D/DRC Case

1401-1431 Assembly Street and 1011-1019 Washington Street

Evaluation Sheet

NATURE OF REQUEST: Request for Certificate of Design Approval for new construction

Site Plan

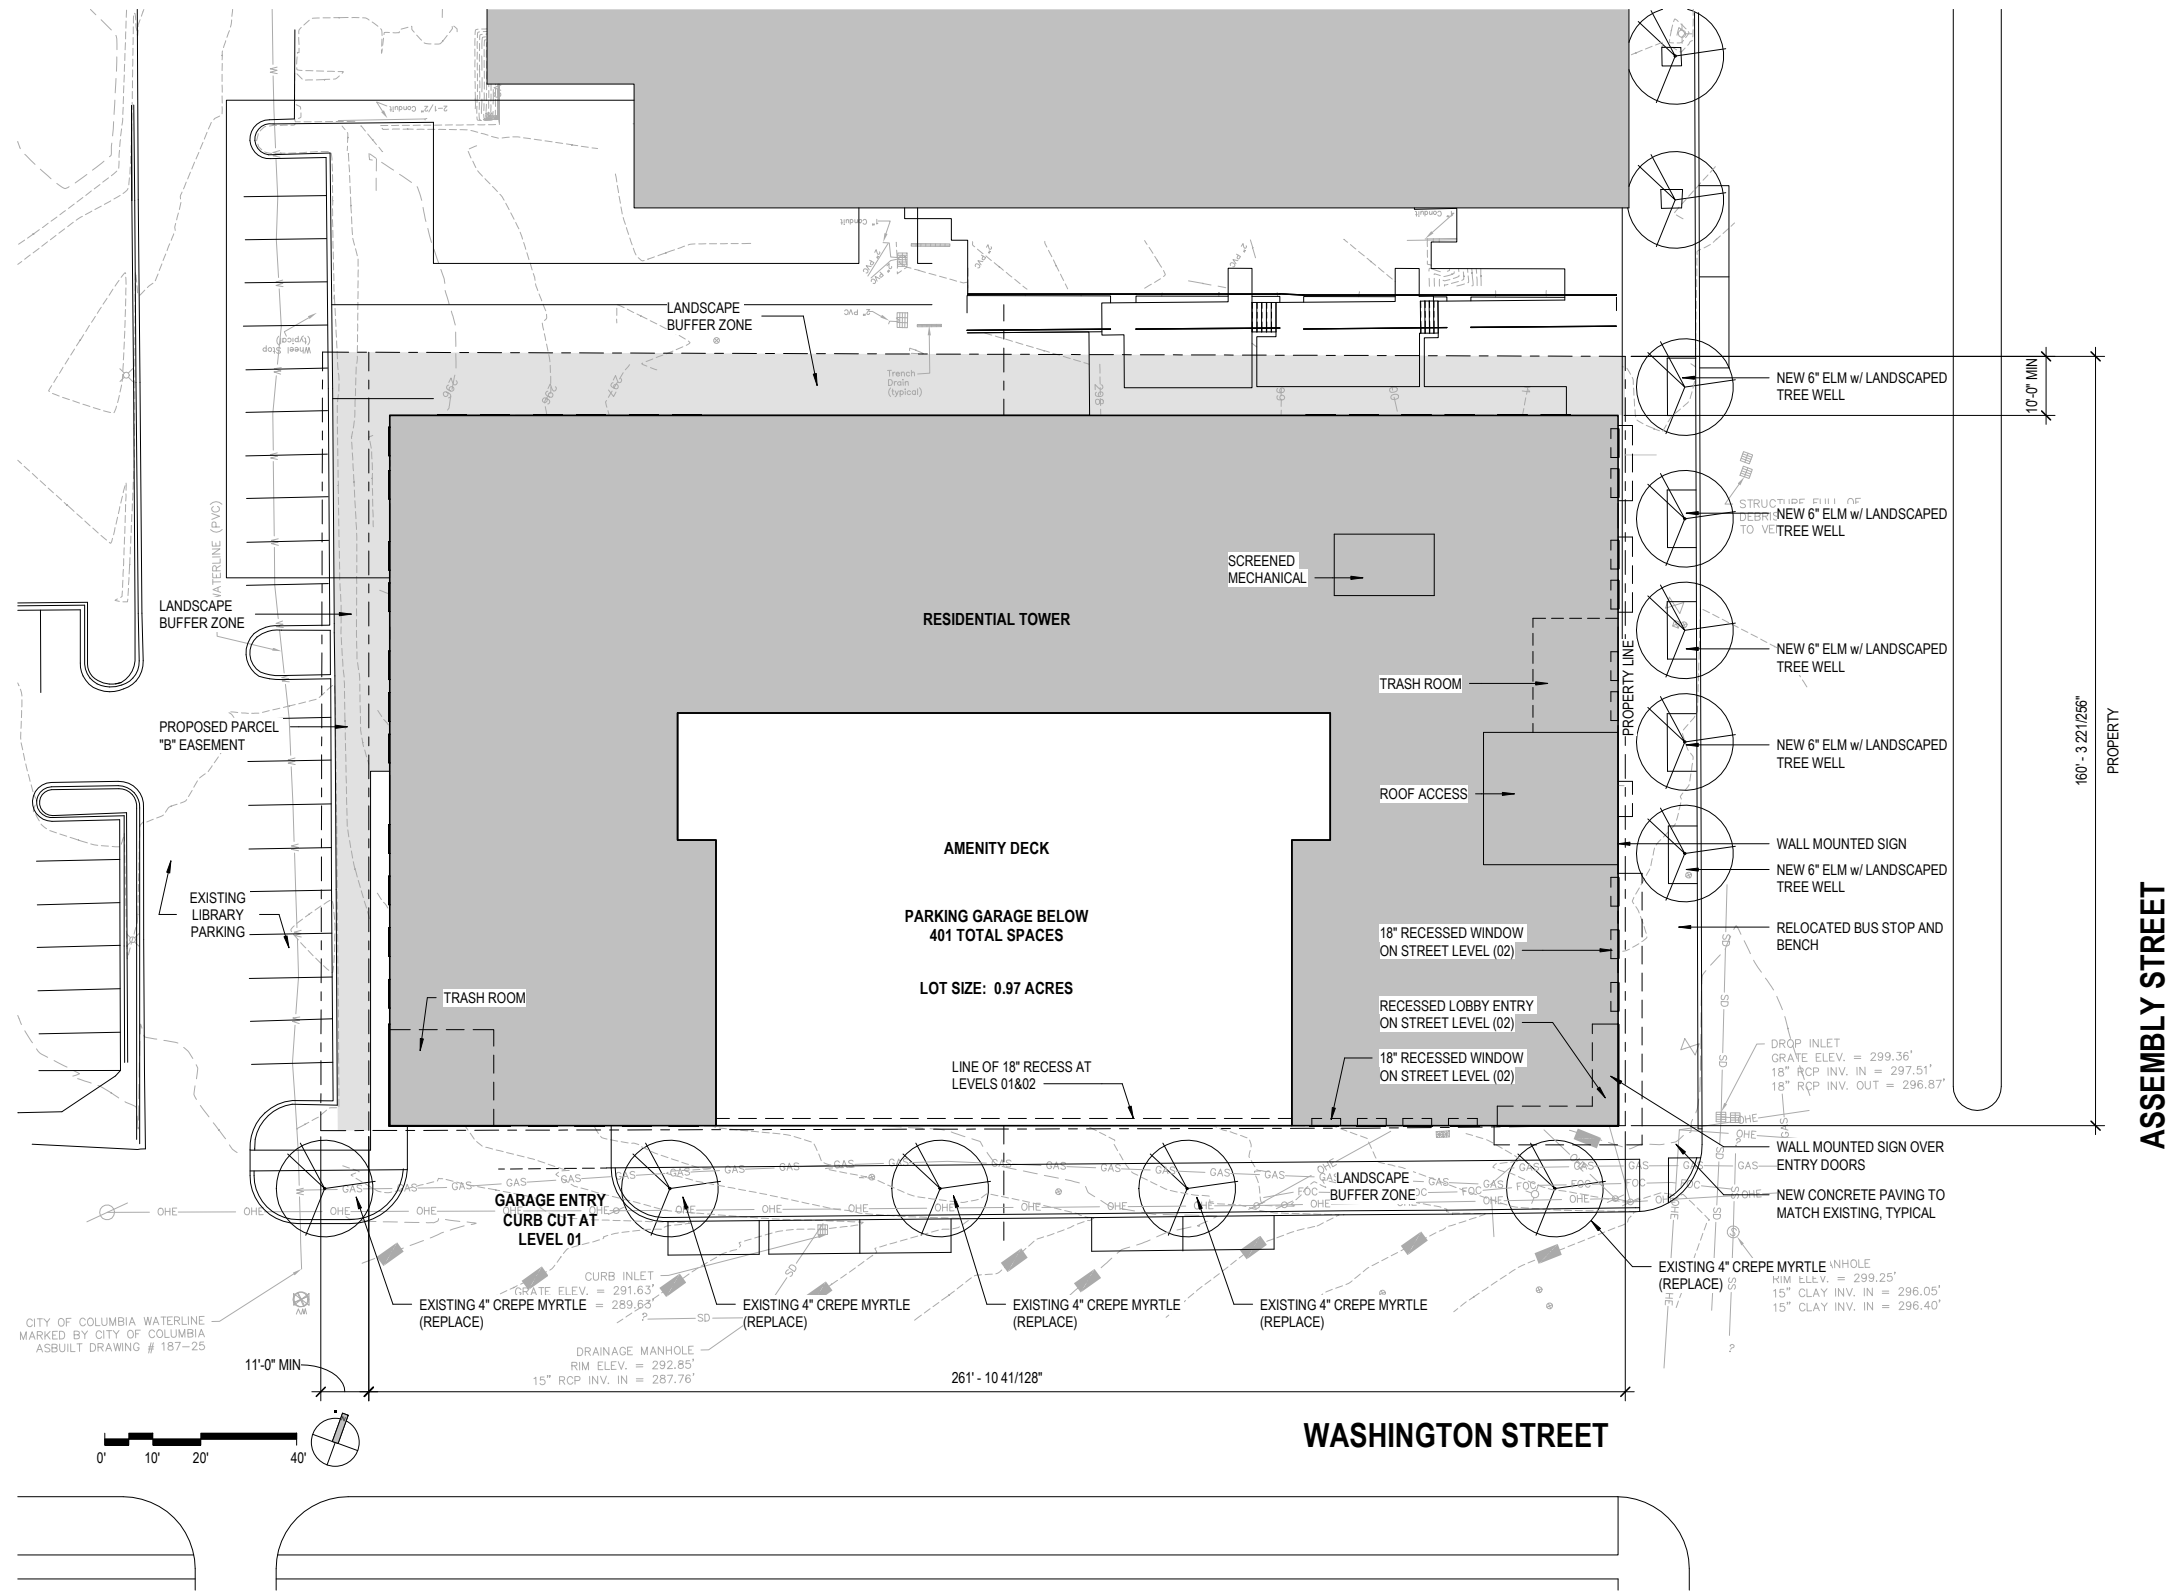
The trash pick-up area has been moved to the Washington garage, enabling the full width of the sidewalk along Assembly Street, which is about 16' from curb to building, allowing for shade trees to be planted and still maintain 10 feet of clearance between the trees and the building.

As noted, the trash service has been relocated to Washington Street, enabling a far improved pedestrian space along Assembly. The applicant should continue to work with staff as the open space between the library and the dormitory is developed.

Window Details

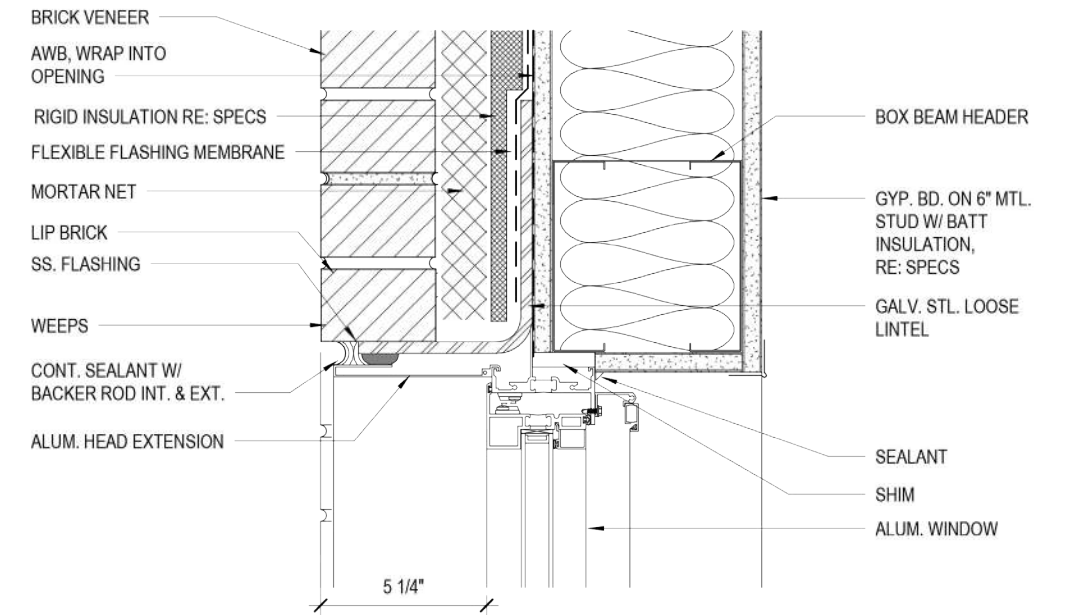
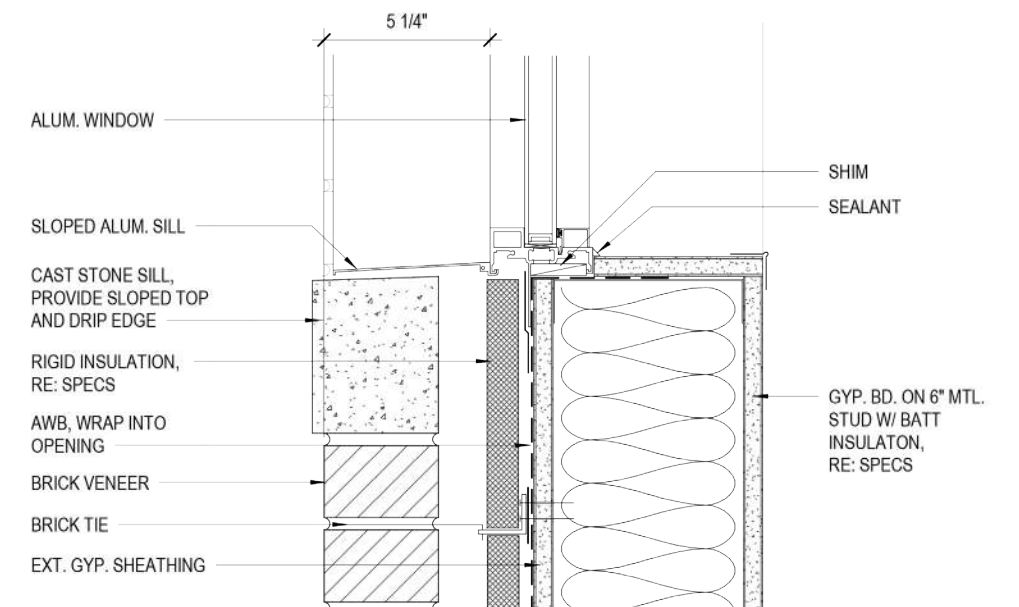
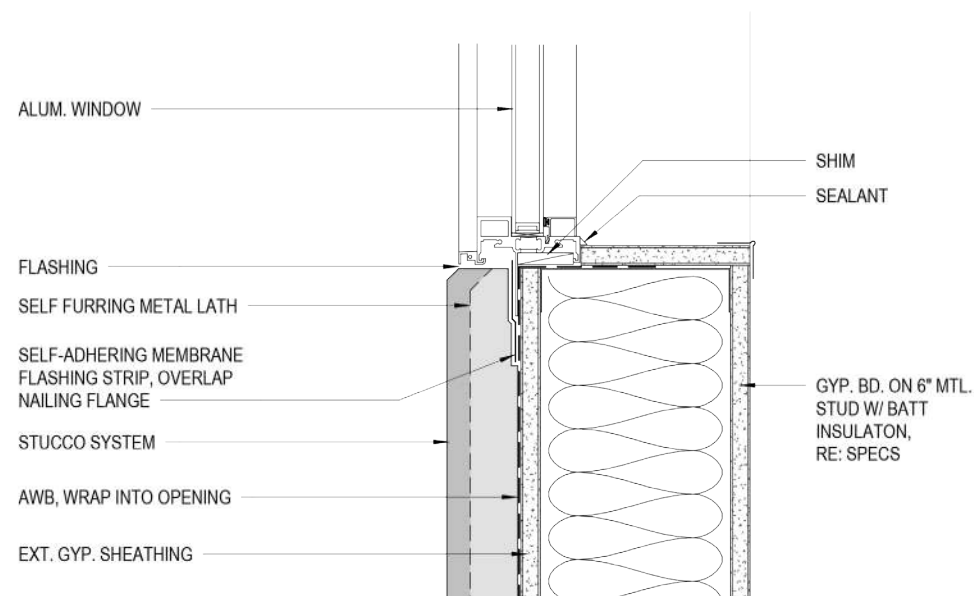
As well, the depth of the window section is critical in articulating the upper facade. The applicant has provided detailed sections of the window configurations. The punched window sections in the brick show a 5" depth with the brick depth and the window frame trim. This is a good depth that should have a distinct shadow line. It is critical that this detail remain part of the design throughout value engineering, and construction documentation.

The stucco window section shows a 1 ½" depth, which is typical for this material.

Z-PURLIN PLAN

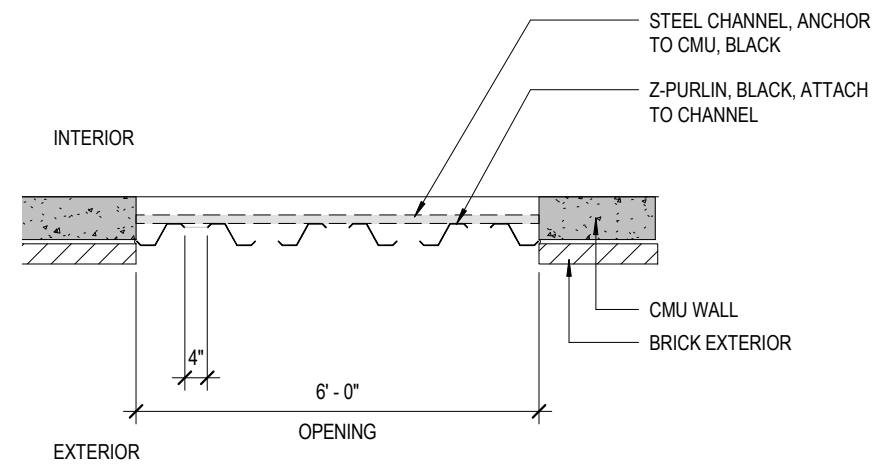
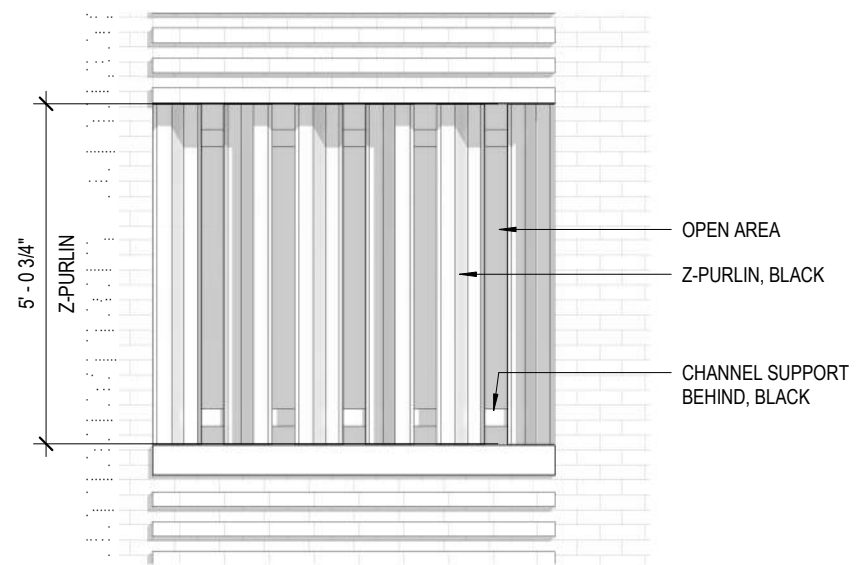
Black steel Z-purlins have been added as a screening detail to the punched garage openings on the eastern tower. These will occur on the Assembly Street side and the Washington Street side, but will not continue to the 4-story garage element or the western tower element due to open garage circulation requirements.

ELEVATION - WASHINGTON STREET_SOLID AREA

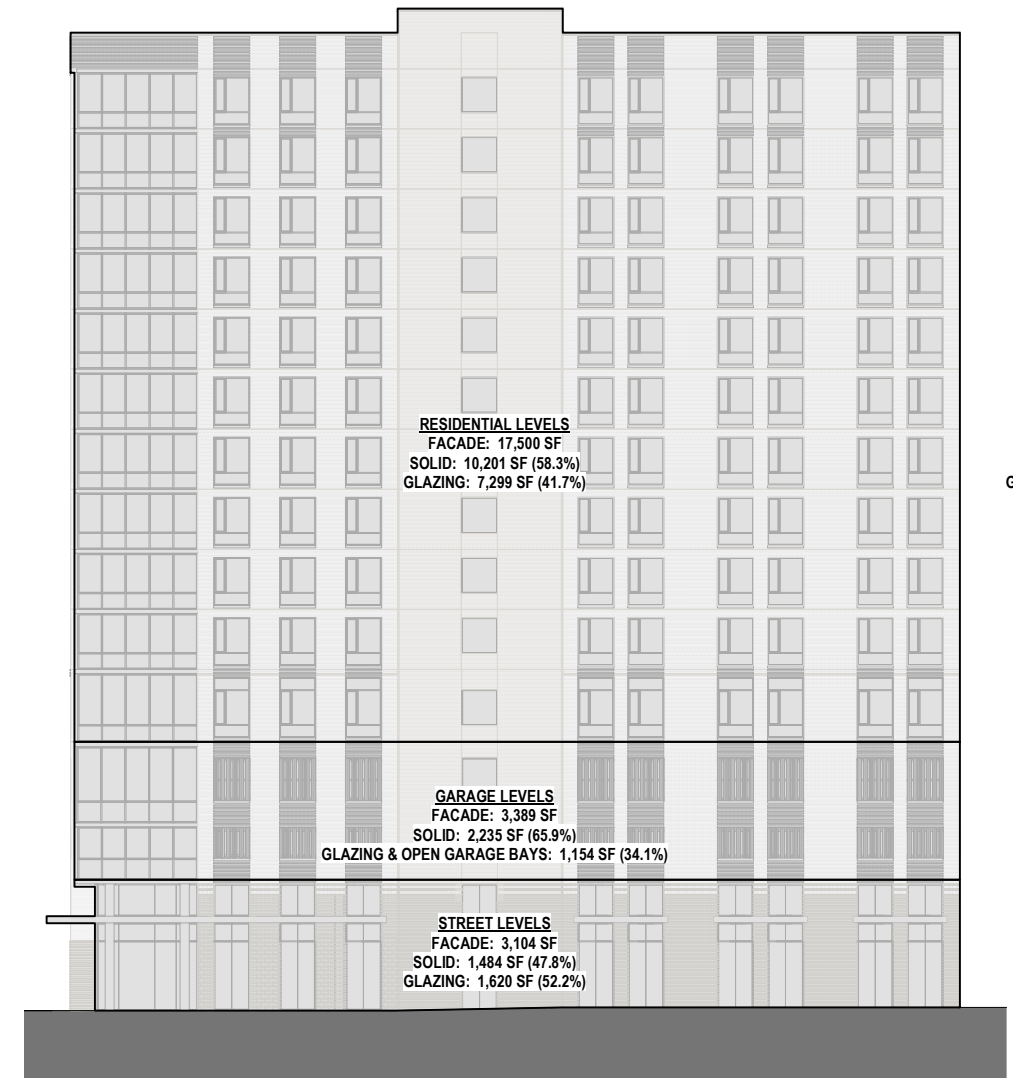
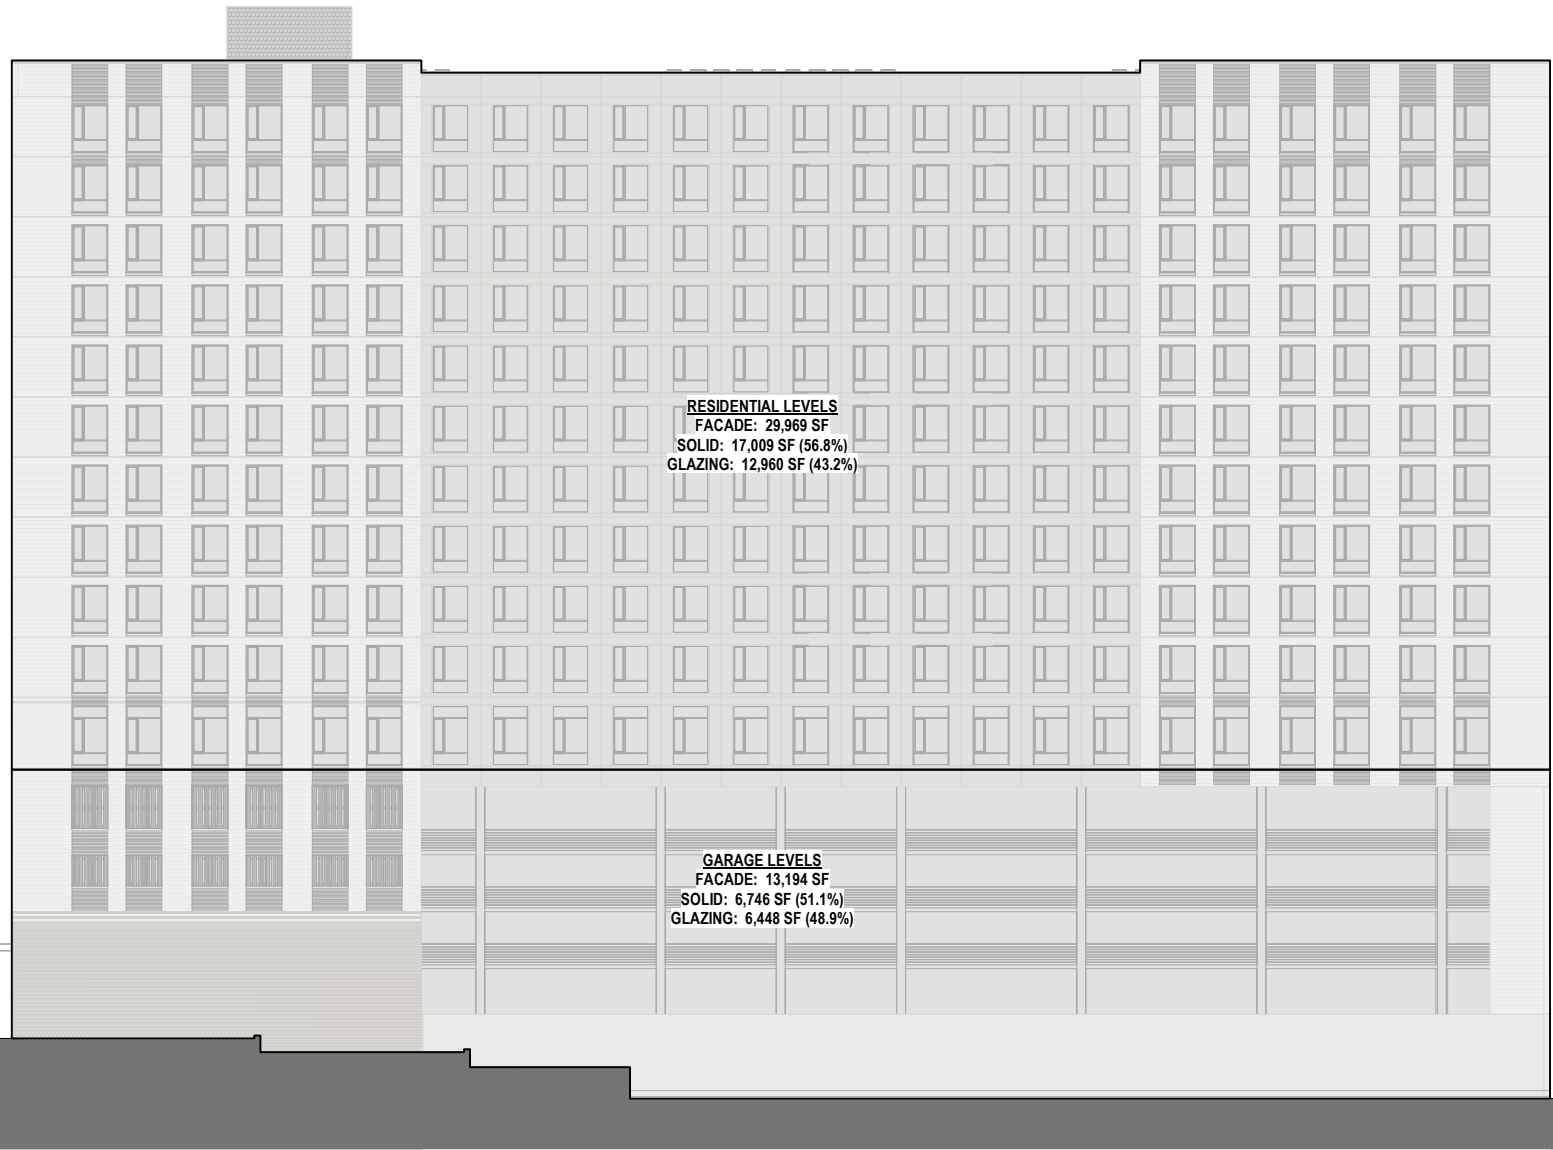
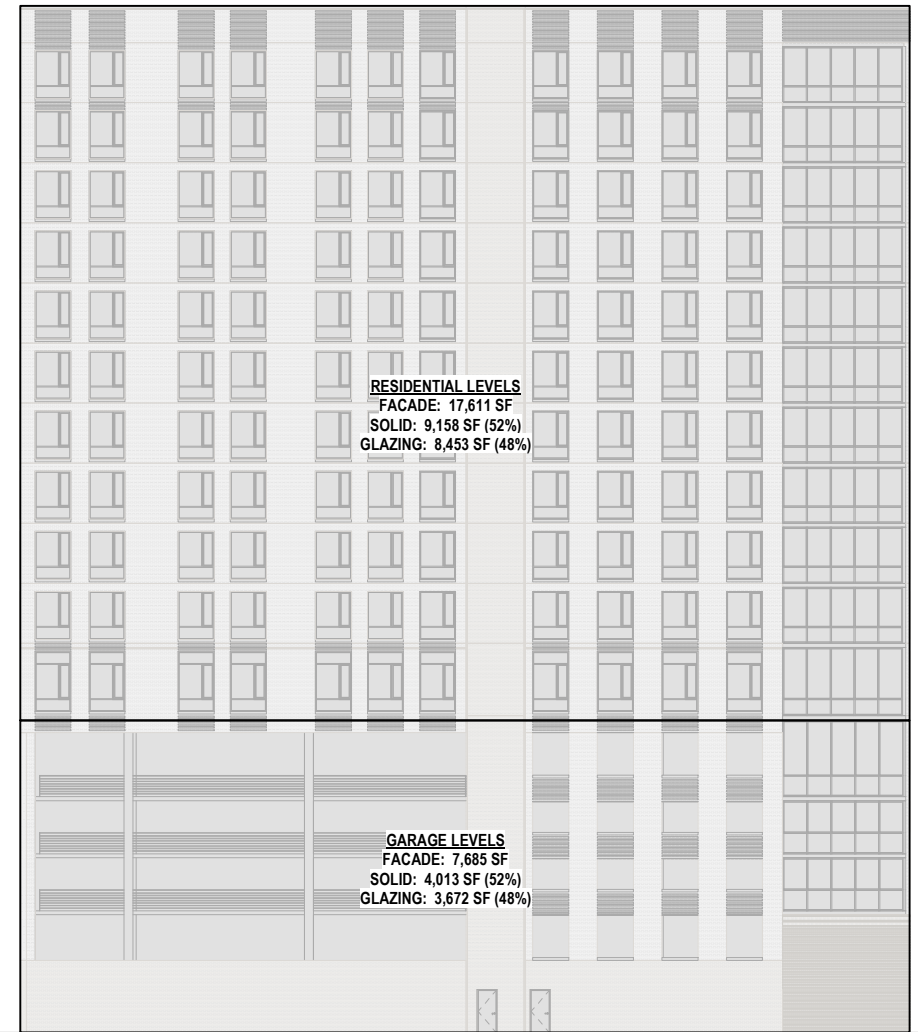
The percentage of openings on both the Assembly Street façade and the Washington Street façade should be provided. The upper floors appear to have a sufficient proportion of openings, however much more is needed on the ground-level frontage, particularly on Washington Street, where about a third of the storefront area is dedicated to garage/service area.

The percentage of openings have been provided, and are included in the packet. As anticipated in the January evaluation, the percentages on the upper floors are close to or above the recommended proportions, but the street-level percentages are below what would typically be acceptable, particularly on Washington Street. The applicant is agreeable to including public art along the Washington Street façade to mitigate the low percentage of glazing.
